MEMORANDUM

To: DRB, SB, UJFD, UCC
From: Rachel Fifield, Planning & Zoning Administrator
Date: 10/13/2015
Re: Agenda and Information for 10/19/2015

Preliminary Review
Albertini 5-lot PRD & Boundary Line Adjustment

C2-01

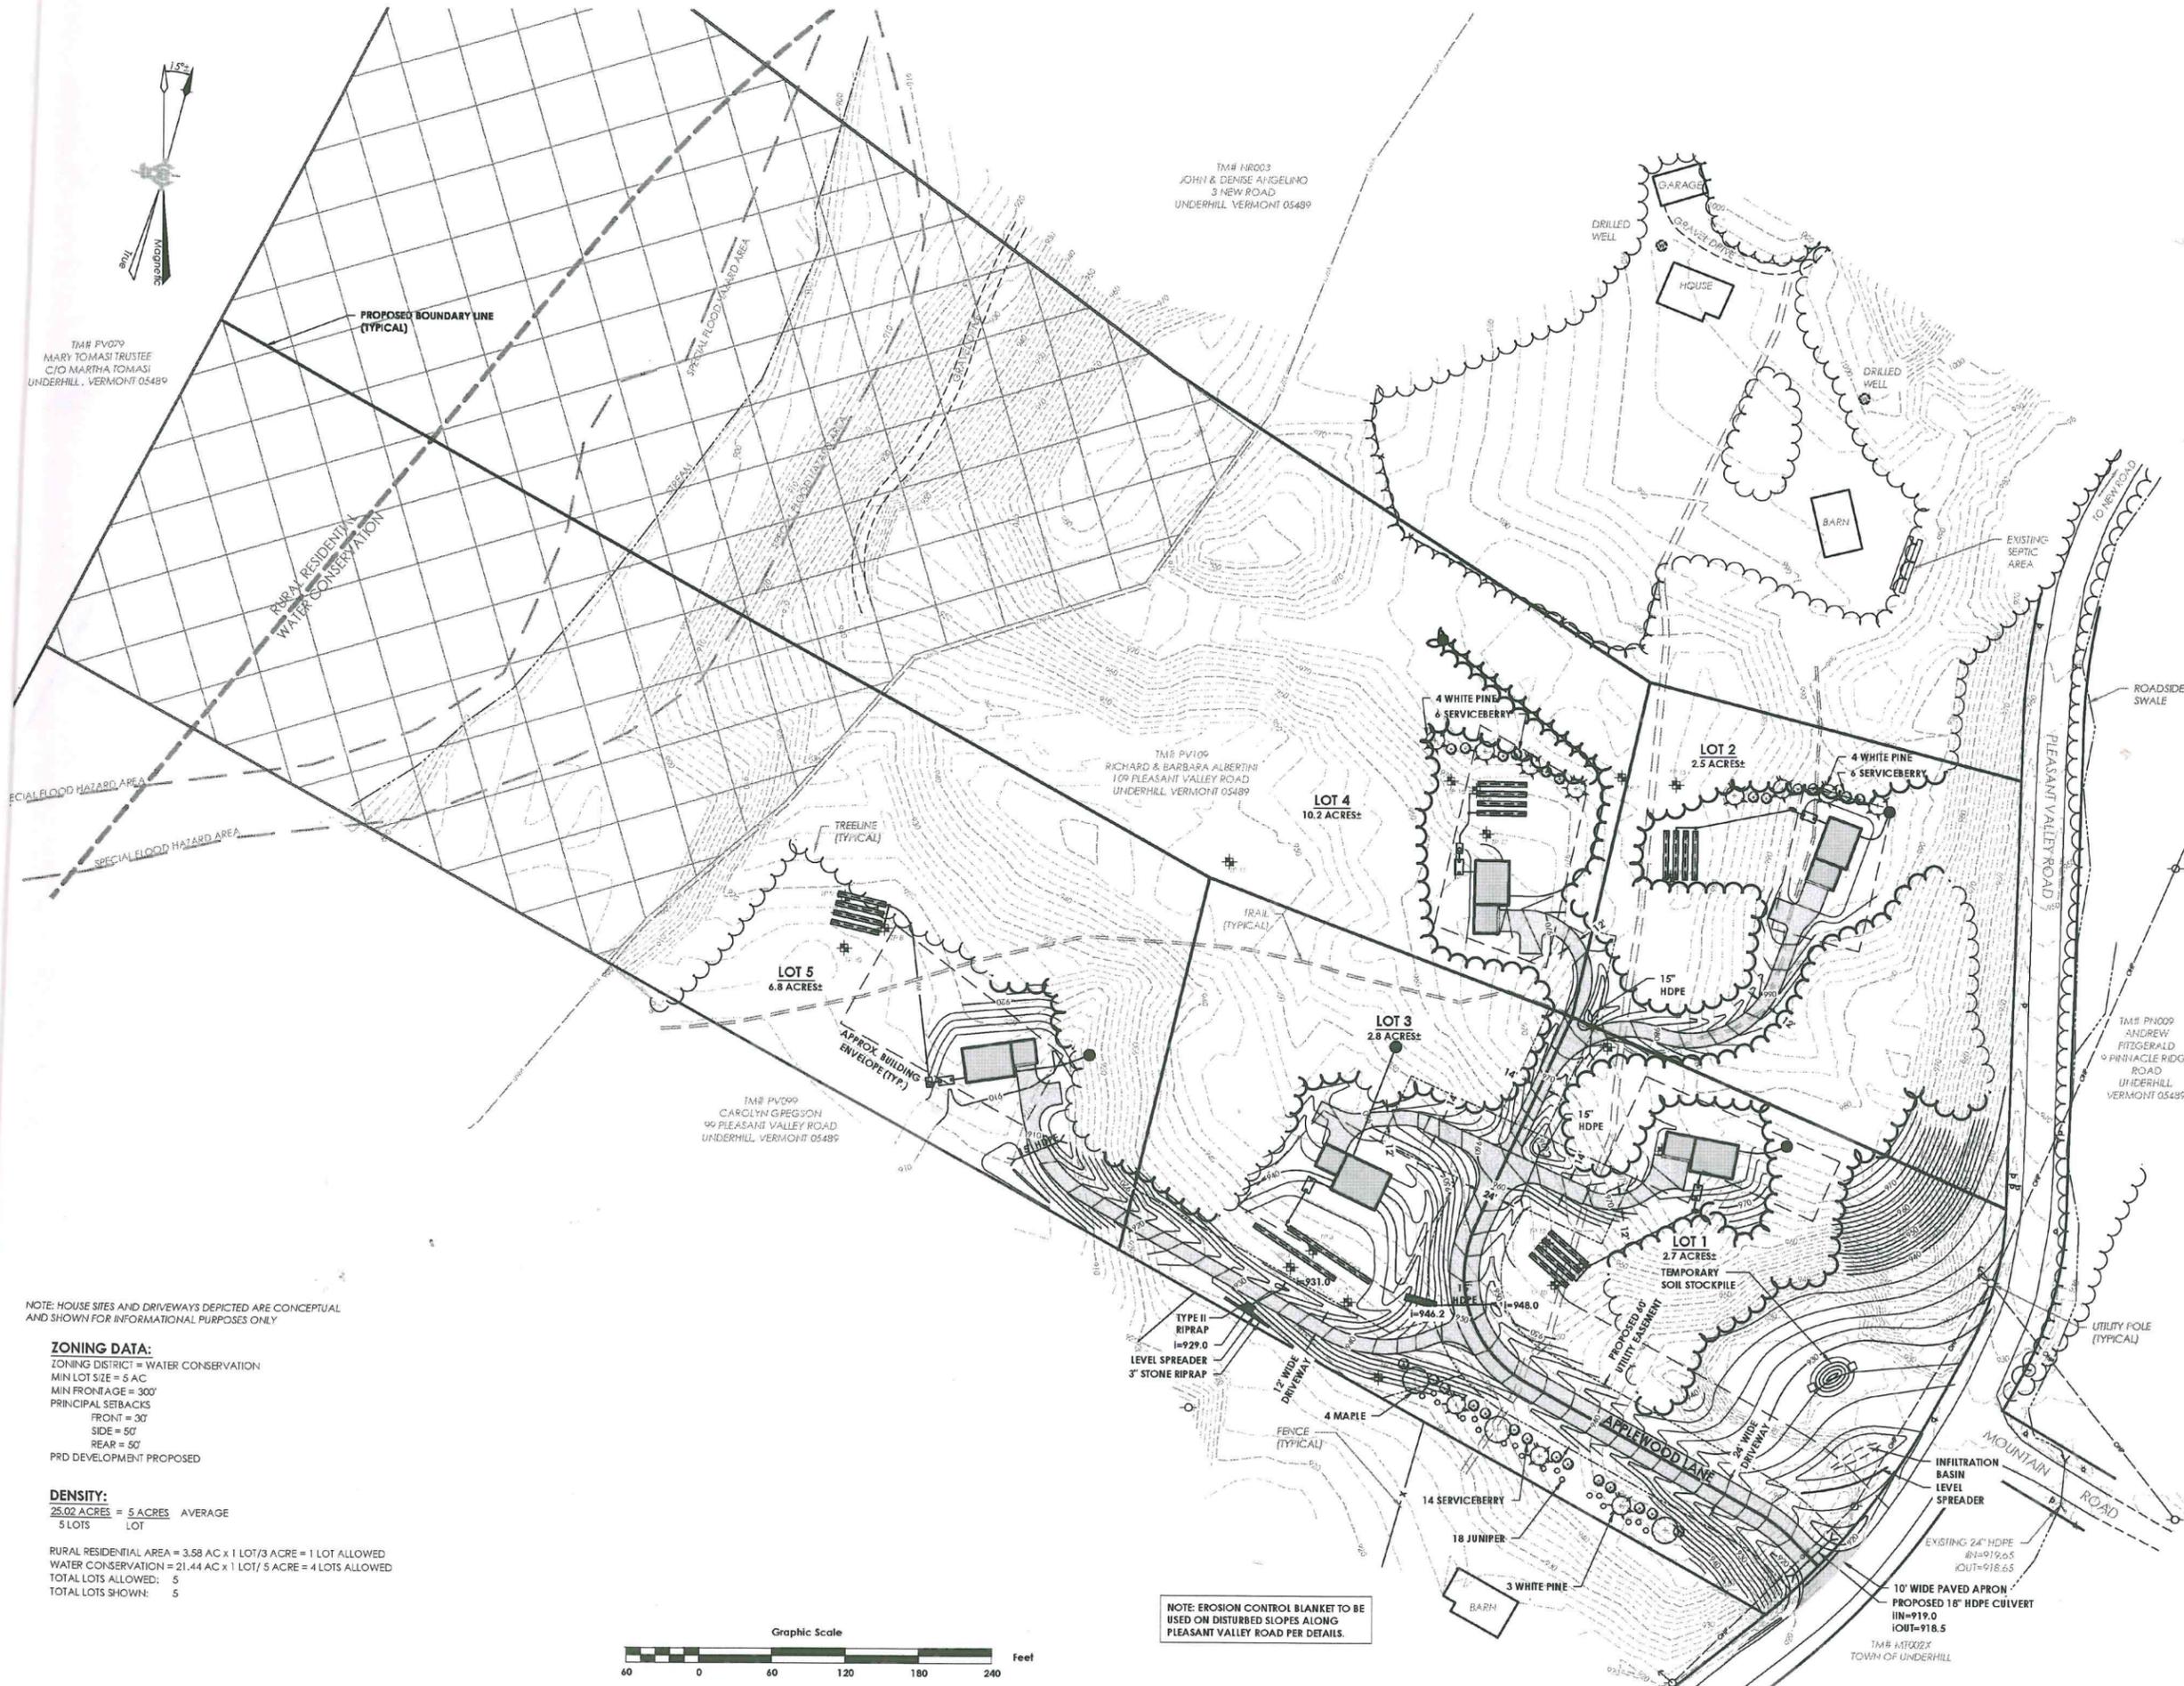
- c) The road profile on Sheet C6-01 indicates that the low point (Sta 0+12) in Applewood Lane at its intersection with Pleasant Valley Rd will have an elevation of 920.7±. Sheet C2-01 gives the inlet invert of the new 18" culvert at this location as being 919.0. This provides approximately 3" of gravel cover over the culvert. Accepted engineering practice is to provide a minimum of 24" of cover. Additional detail (a larger scale plan) is needed showing the proposed modifications to the existing roadside swale south of Applewood Lane along the west side of Pleasant Valley Road towards the 24" culvert to the south.

2. Section 6.4.B - Requires a paved apron of at least 10 ft in length at the base of Applewood Lane if Applewood Lane is to have a gravel surface. Sheet C2-01 specifies a 10 ft wide paved apron. We recommend that the length of the paved apron be extended to at least 30 ft so as to maintain the sag vertical curve at the base of Applewood Lane which otherwise will be filled in by gravel migrating downhill over time.

C3-02

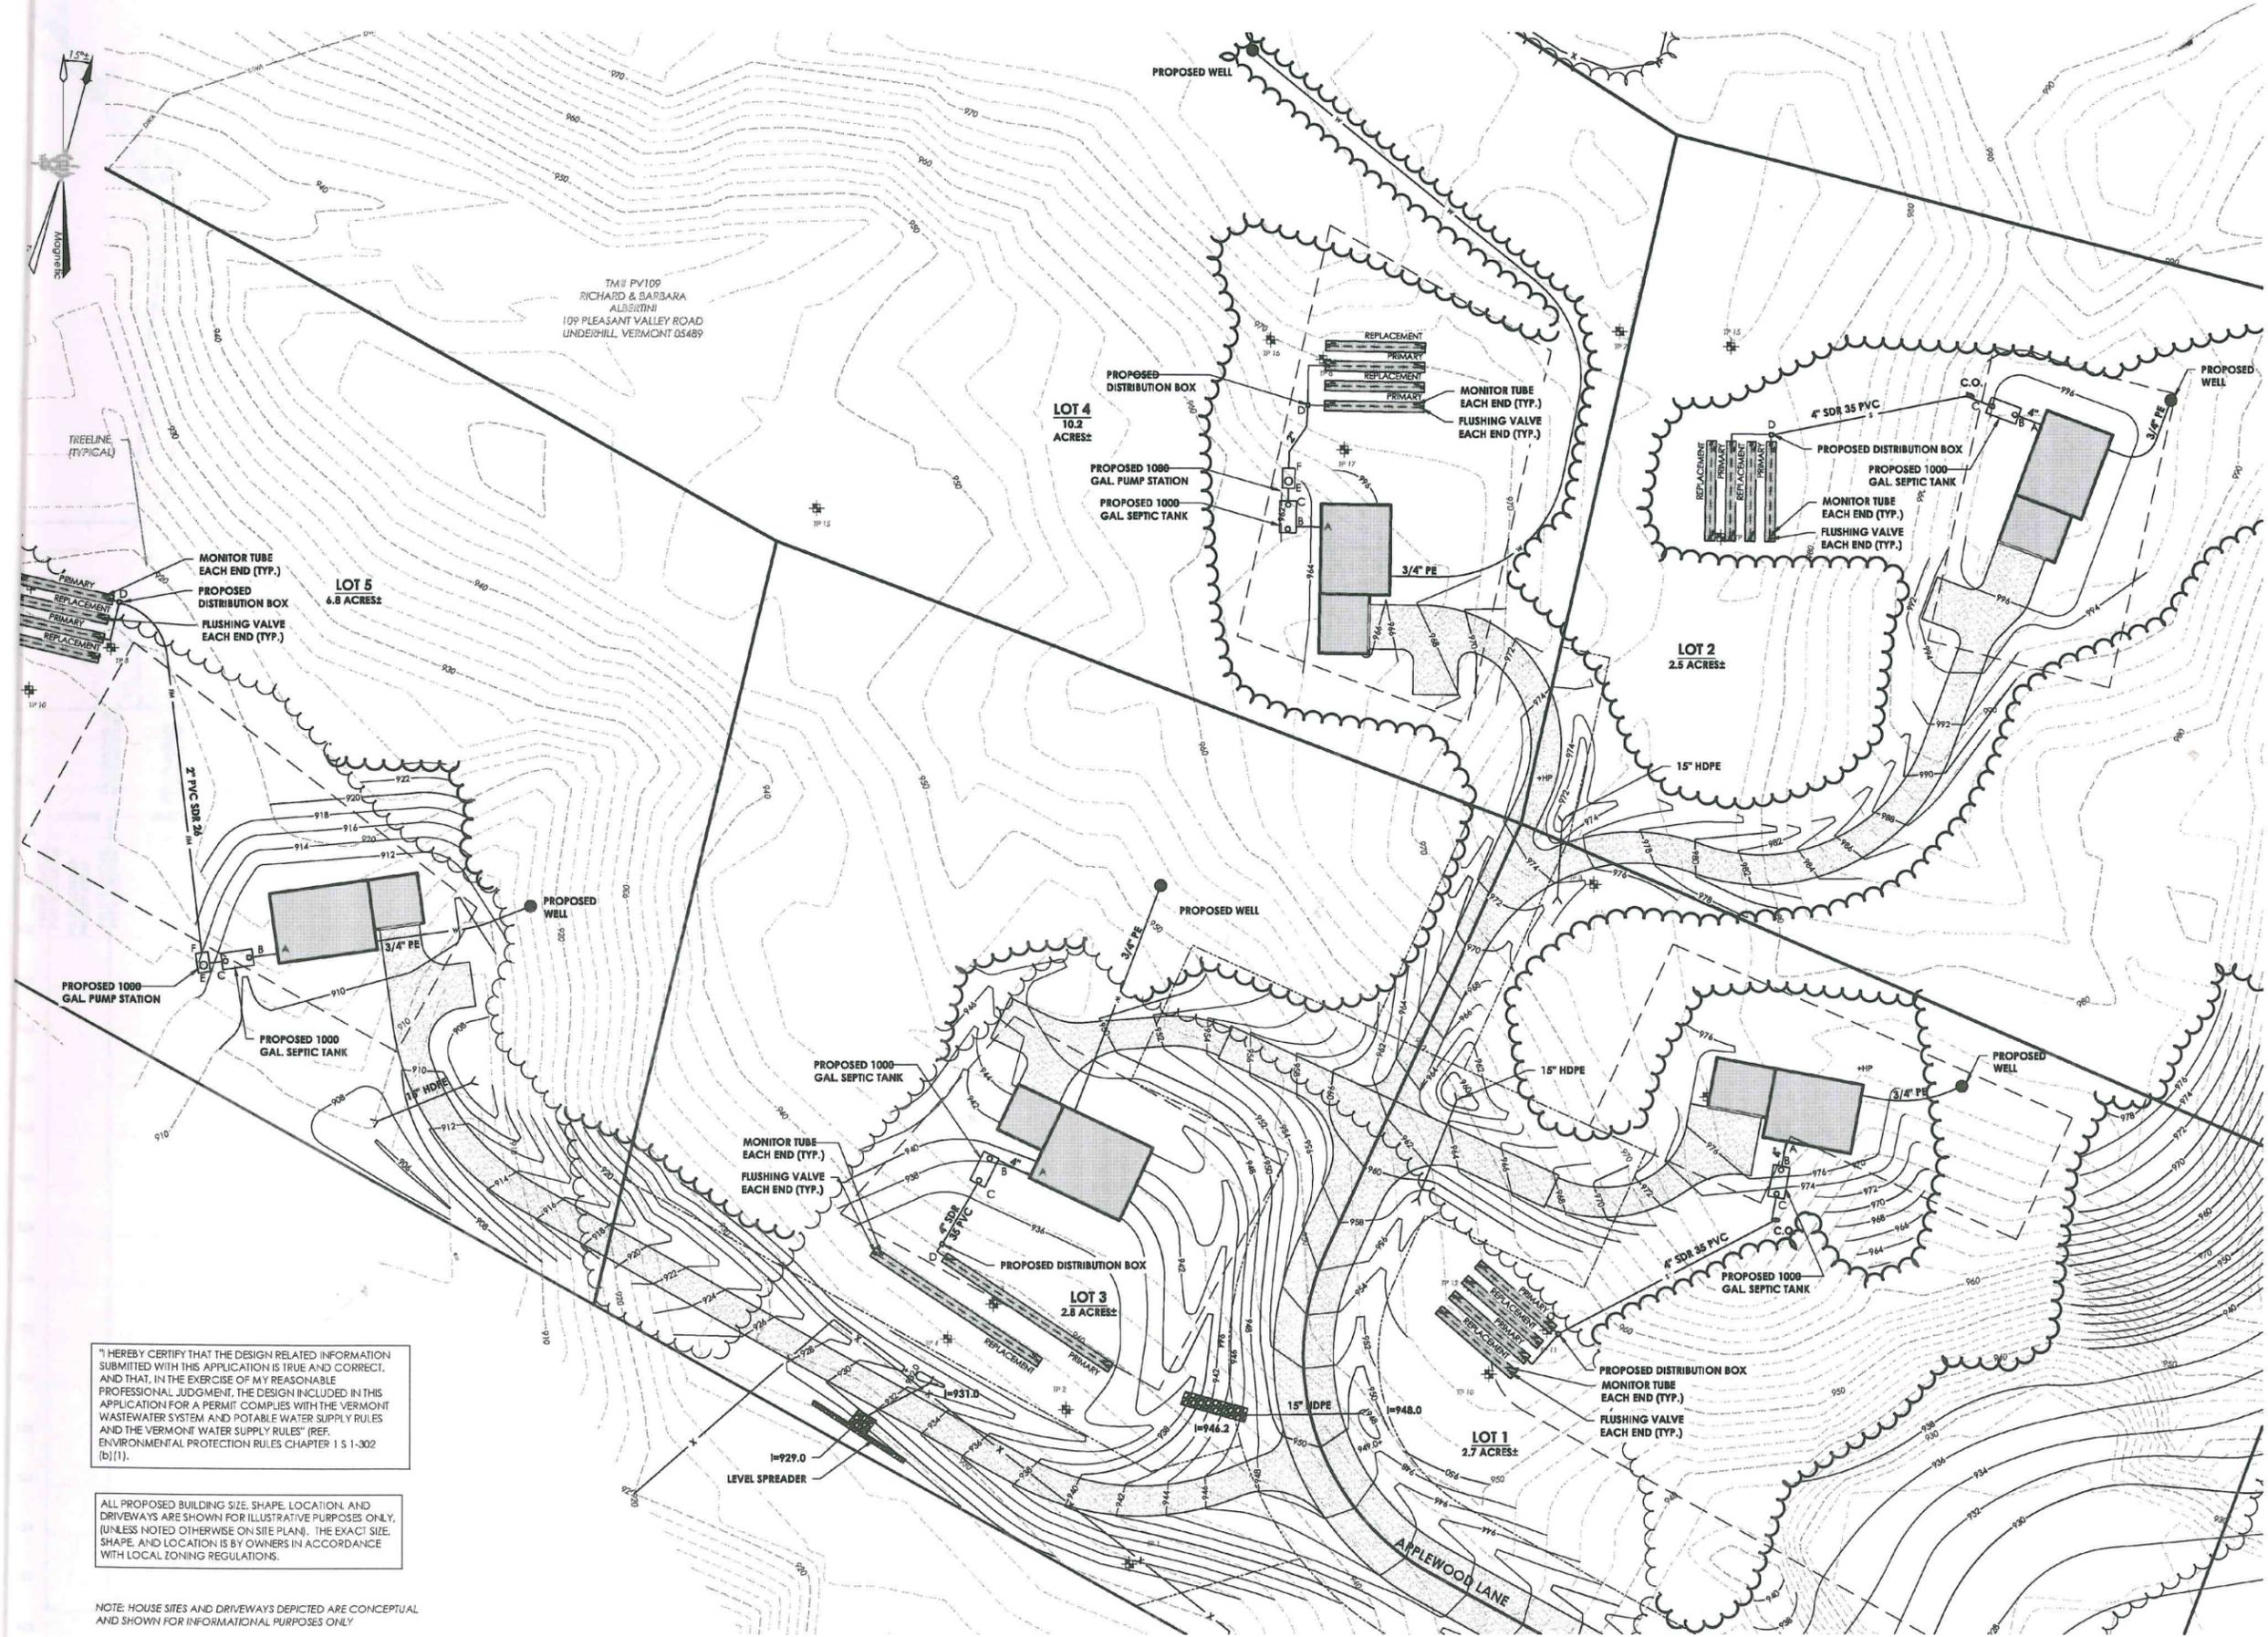
- b) Based on the contours shown on Sheet C3-02 where the driveways to Lots 2 and 4 diverge, it appears that the 18" culvert across Lot 2's driveway may be running uphill. Unless the inlet is intended to have a sump, the outlet of this culvert needs to be extended further downslope.

C6-03

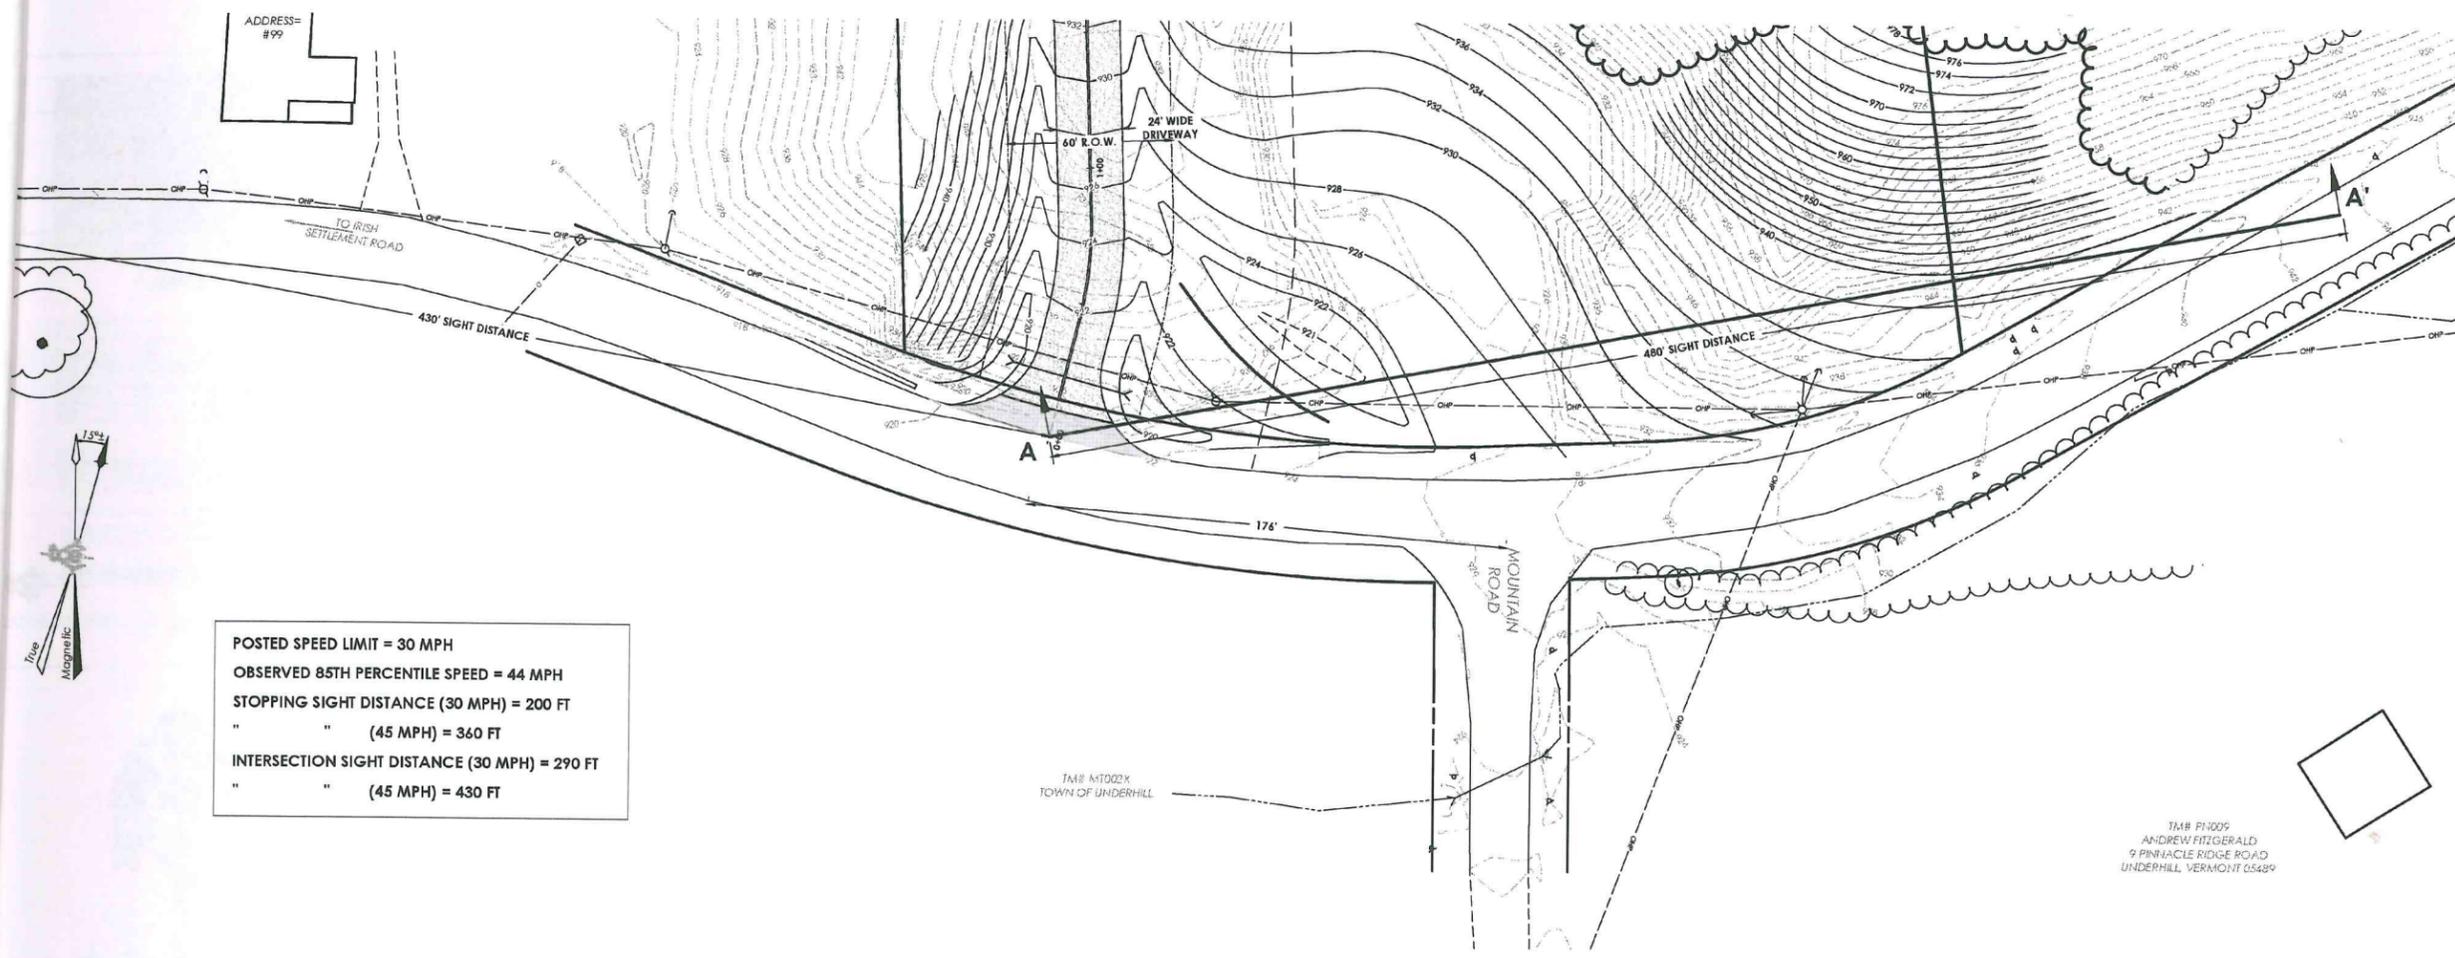
- Questions/comments in light of the Independent Traffic Review:
 - Sheet C6-03 identifies a sightline that extends north over the private property of lots 1 & 2. The southern end of this sight line needs to begin 15 feet back from the Traveled Way on Pleasant Valley. Should legal documents for the subdivision have provisions to require those areas to be cleared for sightlines of southbound Pleasant Valley Road traffic?

- A.4 Sheet C6-03 identifies a sight line (Section A-A) extending to the north over what will be private property on Lots 1 and 2. The south end of this sight line needs to begin 15 ft back from the edge of Pleasant Valley Road's traveled way (Sta 0+15± on Applewood Lane). We recommend that the legal documents for this subdivision include provisions to maintain the land between this sight line and Pleasant Valley Road free of brush, fences and other potential obstacles that would impede the visibility of approaching southbound Pleasant Valley Road traffic.

We recommend that the sight line shown on Sheet C6-03 be revised to start from a point 15 ft back from the Pleasant Valley Road traveled way. This is likely to reduce the actual sight distance available somewhat with the proposed grading as currently shown on that sheet.
